APPLICATION NO.	FILING DATE	FIRST NAMED INVENTOR	ATTORNEY DOCKET NO.	CONFIRMATION NO.
10/604,729	08/13/2003	Xiaokai NIU	4025	1728

Office Action Summary

DETAILED ACTION

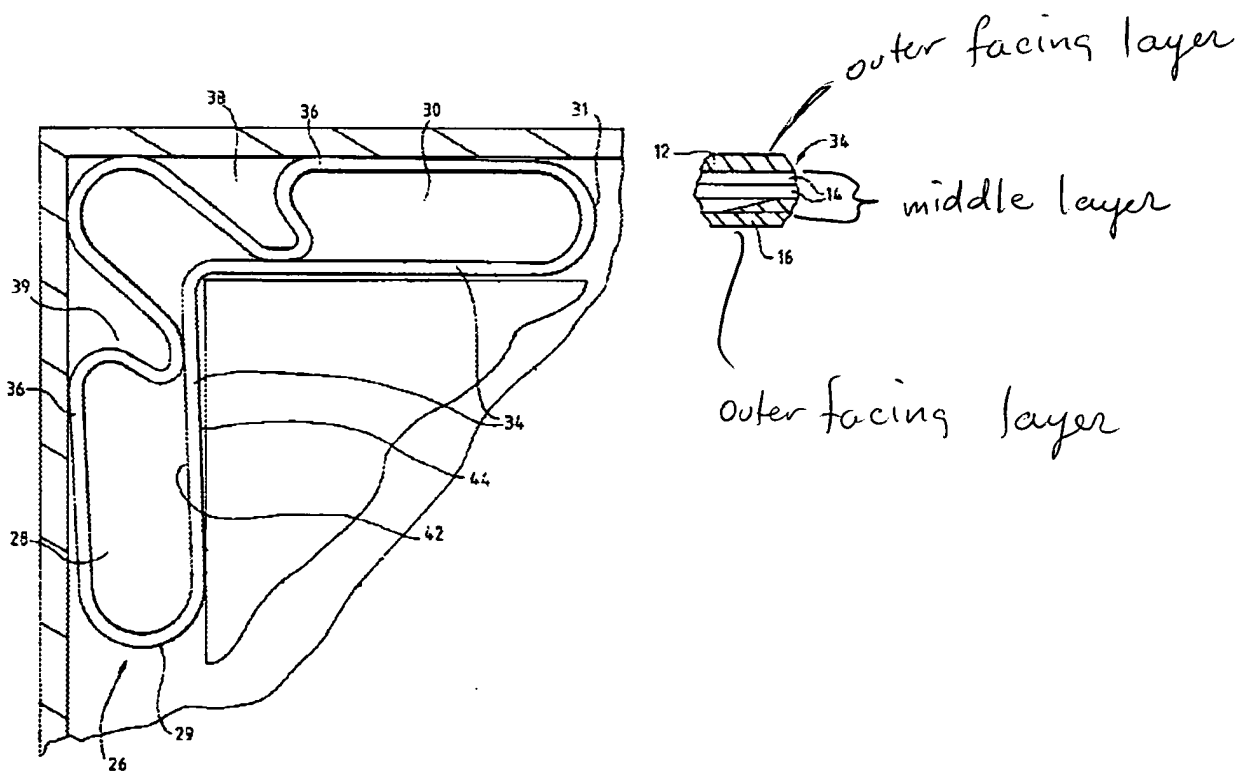
Claim 1 is rejected under 35 U.S.C. 102(b) as being anticipated by Qiu (6,186,329). Qiu teaches each feature of the claimed invention as shown below.

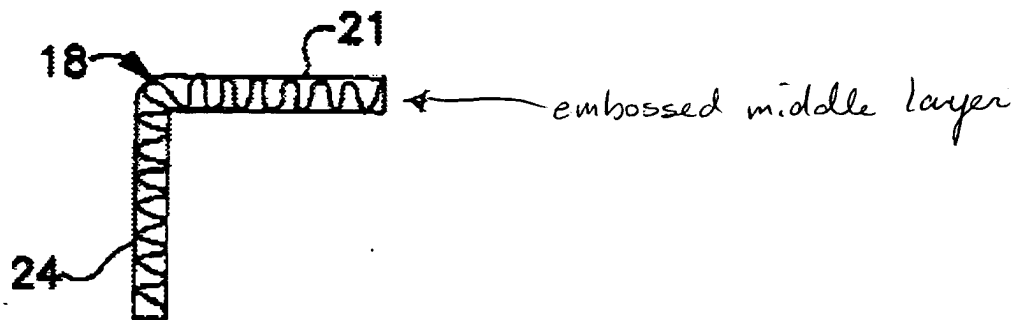
Claim 8 is rejected under 35 U.S.C. 103(a) as being unpatentable over Qiu (6,186,329), in view of Braun (5,799,797) and Liebel (5,131,541). Qiu and Braun teach, substantially, each feature of the claimed invention as discussed above. Neither Qiu or Braun teach a post with varying wall thickness. Liebel, however, teaches varying wall

thickness. It would have been obvious to one of ordinary skill in the art at the time of invention to have modified Qiu to have thicker walls in places expected to experience higher stresses than places experiencing lower stresses.
